NSLPP MEETING HELD ON 05/11/2025

ADDRESS: 8 Eaton Street, Neutral Bay

APPLICATION NO: DA 58/25 (PAN-516571)

PROPOSAL: Demolition of existing dwelling house and swimming pool and

Figure 8: Height Blanket

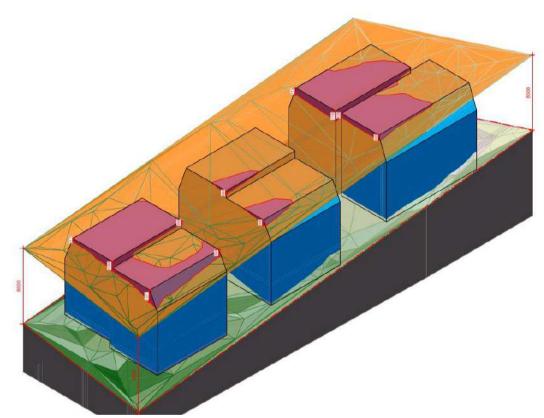
Elements of the development that breach the building height standard will give rise to unacceptable impacts in relation to overshadowing. It is evident from the submitted height blanket diagram above, and the shadow diagrams provided that the shadows cast by non-compliant elements of the building will contribute to an extended duration of shadows during midwinter and at the equinoxes. Whilst shadows cast by compliant elements of the design would present substantial shadow impact, the height, siting and design of the development is not an appropriate response to site constraints, including topography and site orientation.

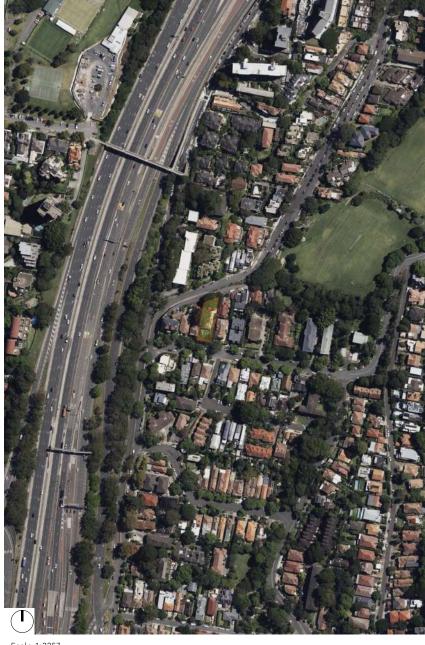
<u> </u>	Changes to second floor arrangements for all units swapping Kolvii ob and bt		
	to meet minimum solar access requirements for each unit. Changes can be found		
	on DA 05.		
В	Elevational shadow analysis for Building B and Building C illustrating solar access		
	for both buildings northern facing facades. Changes can be found on DA 207-213.

Solar access summary provided outlining compliance to minimum solar access for Units 3,4,5,6. Changes can be found on DA 214.

2pm Shadow Analysis - Solsitices

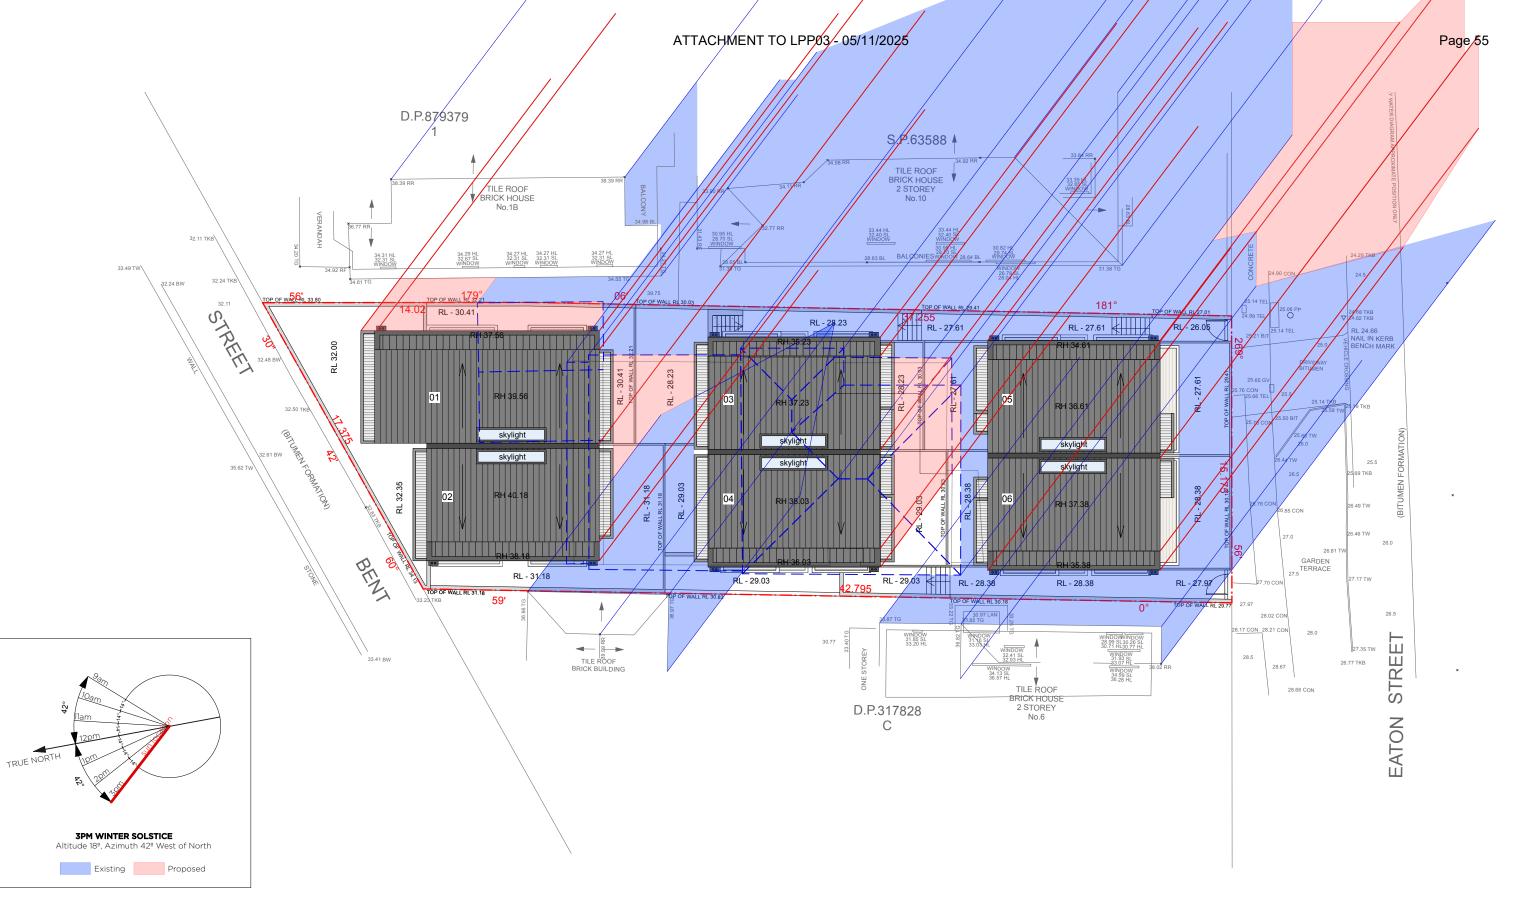
- c) Elevation shadow diagrams at intervals at 2pm & 3pm for unit Nos 04 and 06 which do not correlate with plan view shadow diagrams and have not included shadows cast by adjoining development.
